MILITARY SPECIFICATION SHEET

ADAPTER, CONNECTOR, COAXIAL, RADIO FREQUENCY,
(WITHIN SERIES BNC), CLASS 2, STRAIGHT PLUG

This amendment forms a part of military specification sheet MIL-A-55339/15, dated 6 May 1975, and is approved for use by all Departments and Agencies of the Department of Defense.

FIGURE 2, delete and substitute:

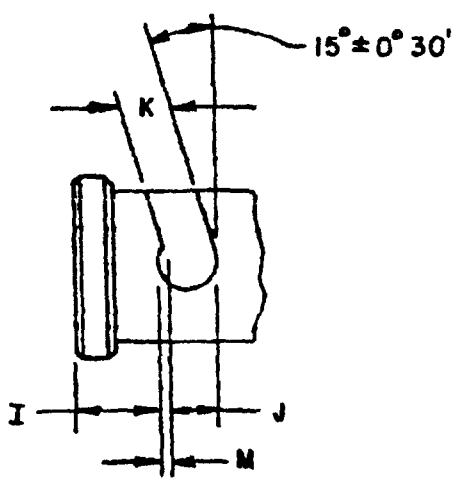
FIGURE 2, maximum column: Add dimension E ".230 (5.84) and dimension P ".228 (5.79)".
